Arnsberg (Germany), January 2018

Urgent safety information

Safety information regarding the affected products of the Aurinio L 110, L 120, L 150 and L 160, Aurinio OR lights series

Figure 1: Overall system of the Aurinio OR light – affected component marked

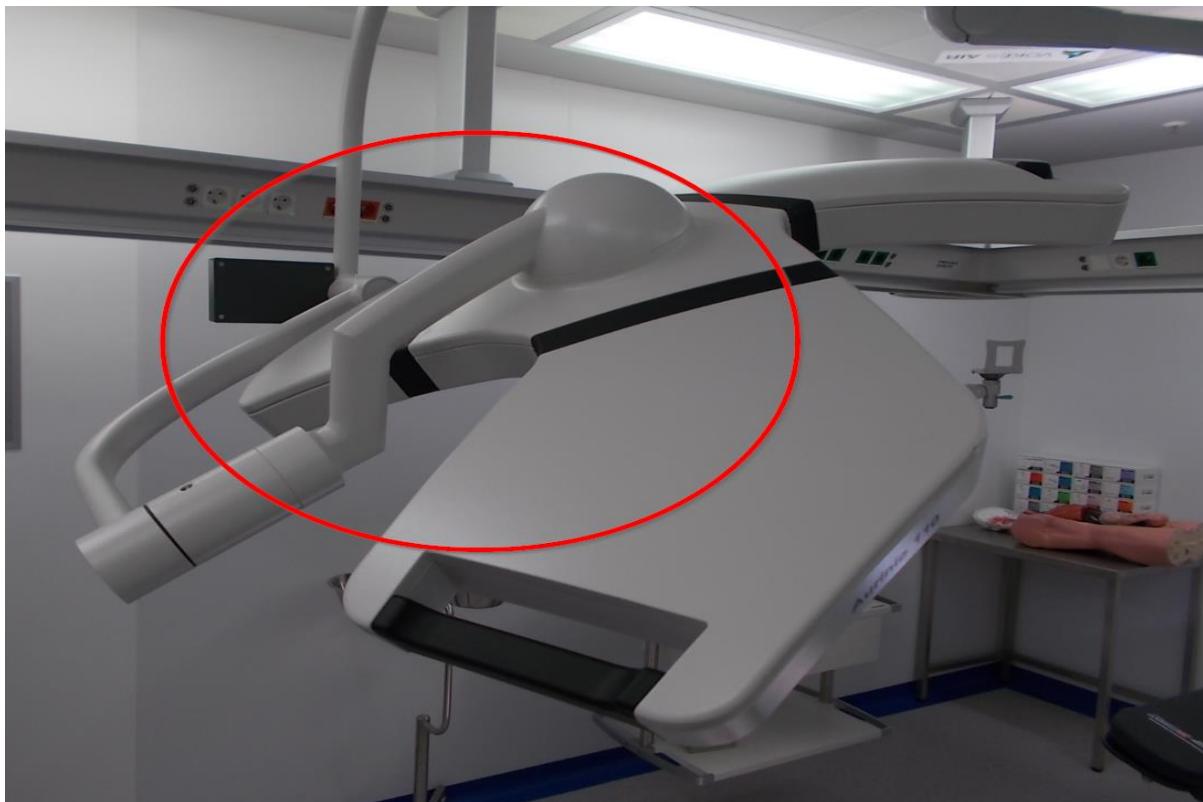
In the context of our worldwide product monitoring, we have determined that a formation of tears can occur in the support structure of the aforementioned lights. This results in a situation where the load-bearing capacity may potentially no longer be ensured and may lead to a material breakage at the welding seam of a component of our OR lights.

The breakage is preceded by the formation of tears in the construction, see Figure 1-3.

Figure 3: Light's connection – tear observable

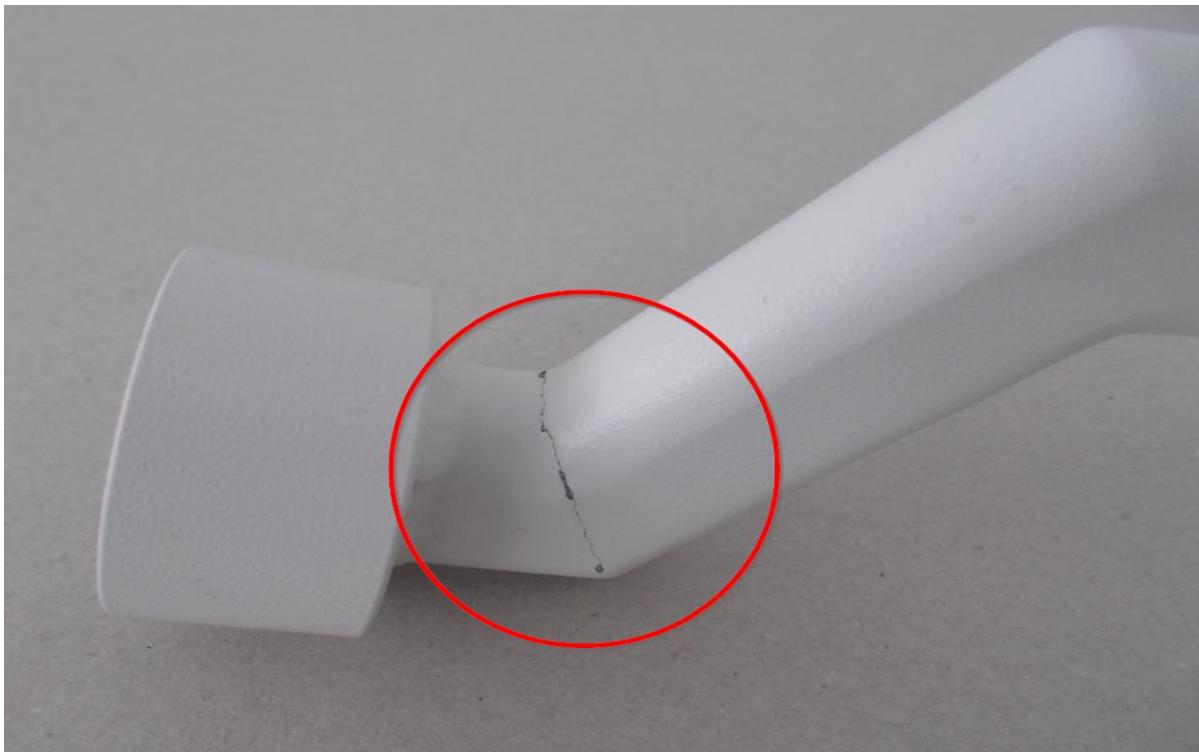
In case of such a failure, the light's connection of the product breaks, which may lead to injuries to the patient, users, or third parties due to the turning down of the light. Also, to date we were not able to reproduce any spontaneous breakage of the light's connection. Based on our research, the breakage of the light's connection is preceded by the formation of a tear of the

paint on the surface. This can be checked via a visual inspection. The gap that occurs is increasing slowly.

The following figure shows the affected component (light's connection) with the formation of tears to be potentially observed.
